**GETTLER-RYAN INC.**

**Subject: Addendum 1 to GR Report No. 6420.02-1, *Work Plan For Monitoring Well Installation* (dated December 17, 1997)**

**SITE PLAN**  
 First Nationwide Bank  
 3900 Piedmont Avenue  
 Oakland, California

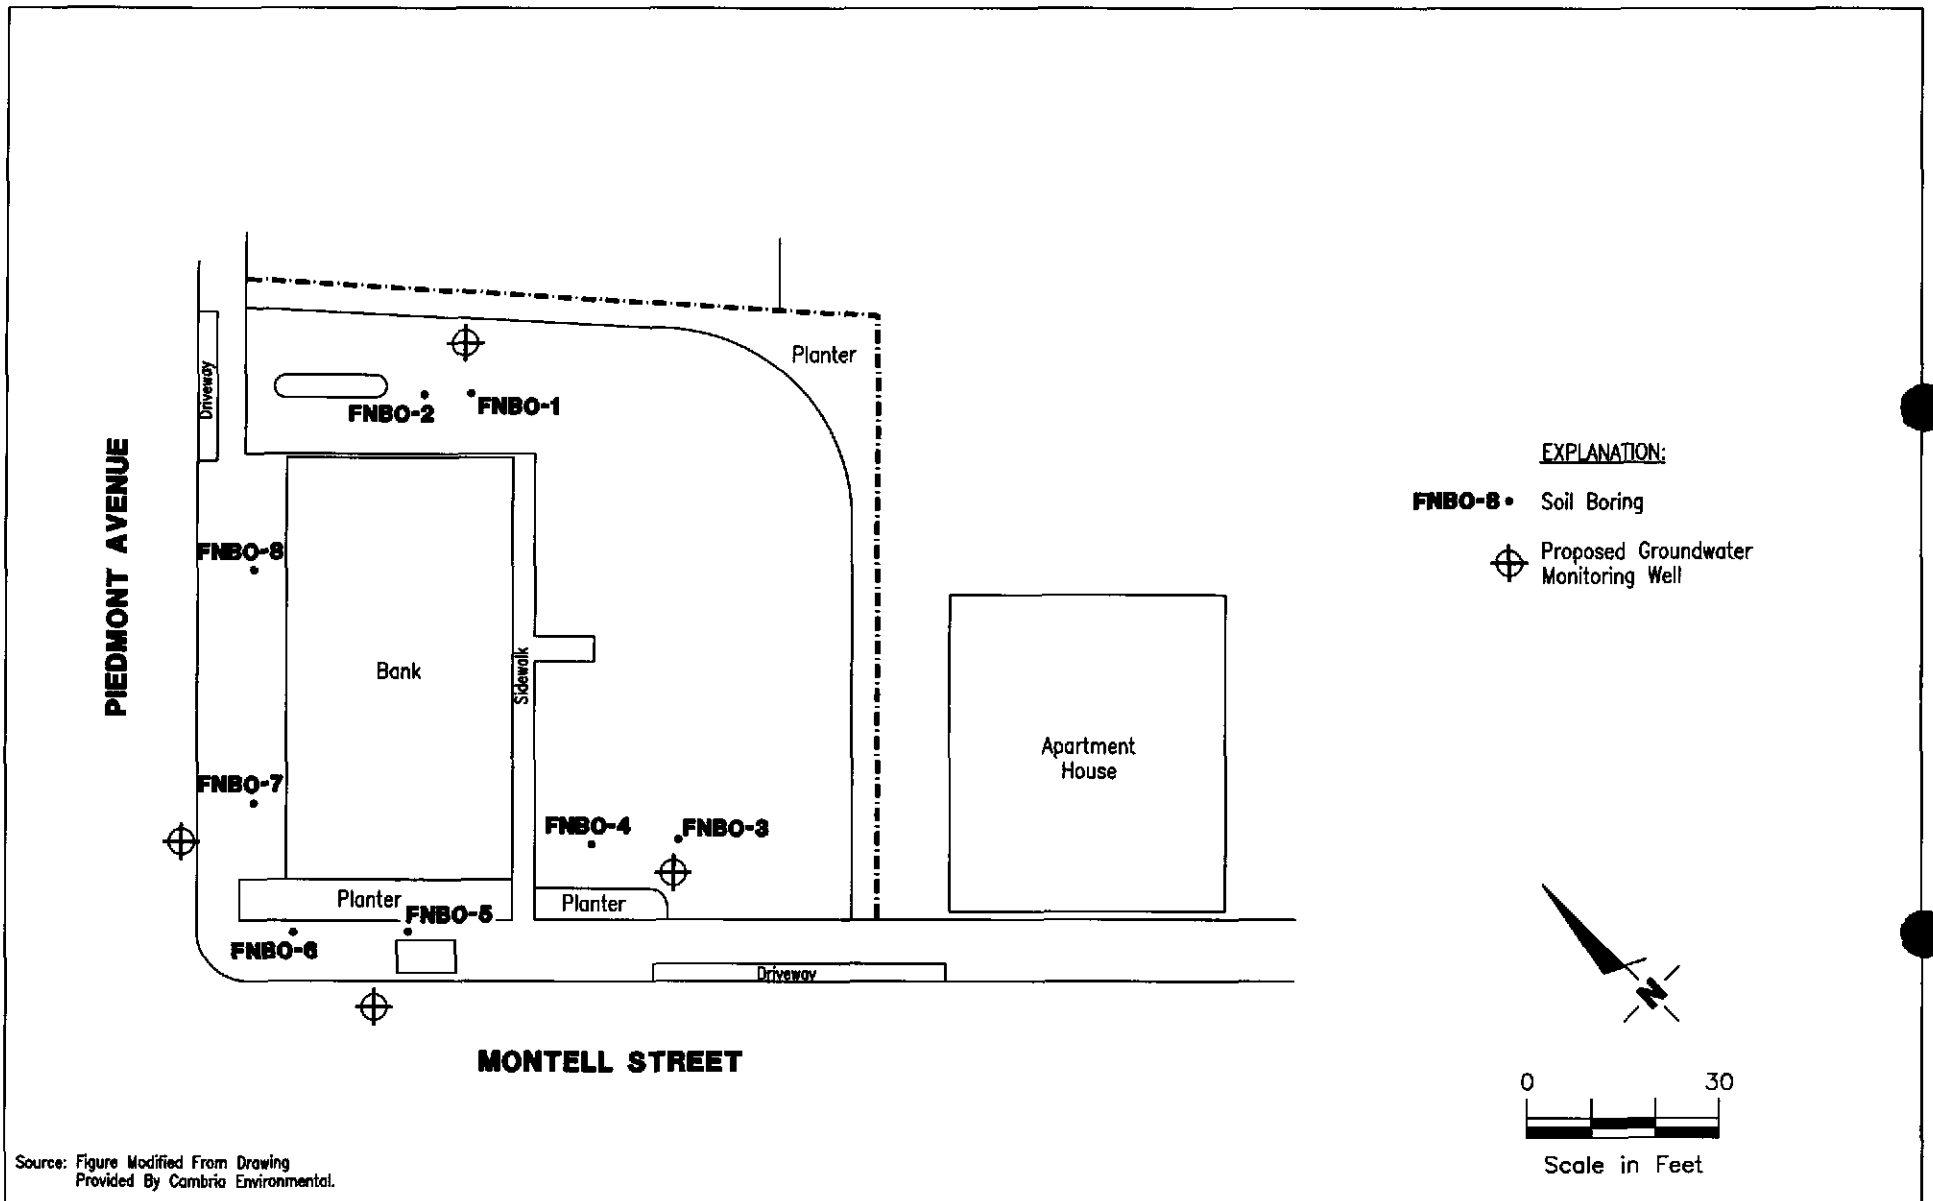
During our telephone conversation of January 26, 1998, you requested that the well Gettler-Ryan Inc. (GR) proposed to install near the southeastern property boundary be moved closer to the locations of soil borings FNBO-3 and FNBO-4. GR will move the location of this proposed well so that it is situated between boring FNBO-3 and the sidewalk. A revised site plan is attached.
